| ViseStopv2 |
| xy_Joint_2 |

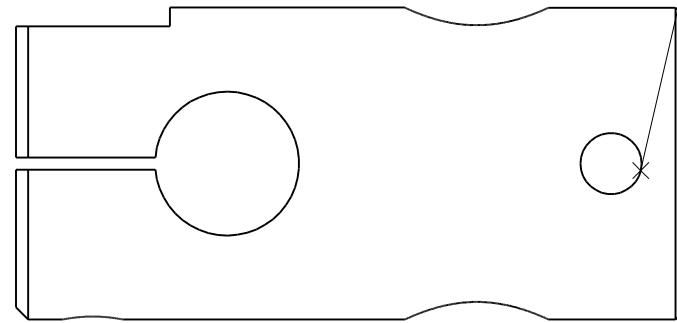
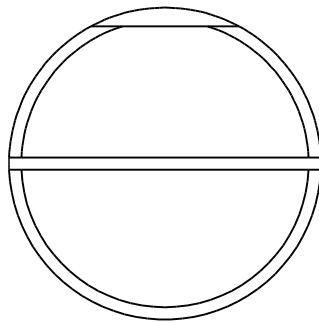
The main difference between this Joint2 and Joint is the flat on the right end has been rotated 180 degrees to the opposite side along with the associated hole diameters. This is so the SHCS for clamping can face the same direction when assembled.
